State, Federal and Tribal Fishery Agencies Joint Technical Staff Memo

SUBJECT: Spring Spill Operation at Lower Monumental Dam

DATE: June 26, 2012

Figure 1. Smolt passage data and flow and spill operations at Lower Monumental Dam, May 1-May 31, 2007. Full sampling for the Smolt Monitoring Program at LMN did not begin until May 12th sample.

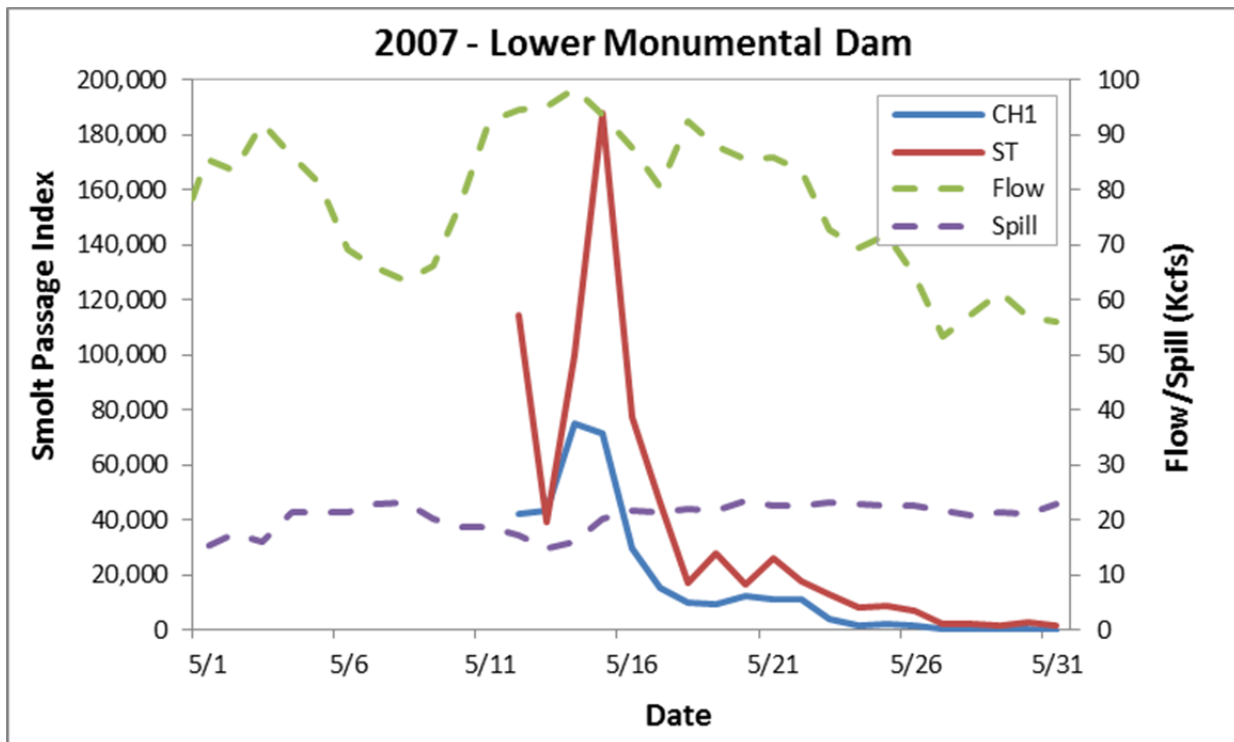
The bulk spill pattern was originally accepted based on research showing that a uniform spill pattern, with smaller spill gate openings at lower river flows, resulted in slightly higher injury and mortality for spillway passed fish. Because of these concerns, the Salmon Managers continue to agree with using the bulk spill pattern at total river flows less than 60 Kcfs. However, in recent years concern has been expressed that the TDG production and consequent spill curtailment that occurs with the use of the bulk spill pattern at higher flows is problematic for RPA 29. Adherence to the bulk spill pattern up to flows of 140 KCFS often necessitates the COE water quality personnel to reduce spill amounts (to avoid exceeding the Ice Harbor forebay TDG standard) just as large numbers of smolts arrive at the project (see Figures 1&2 for examples).
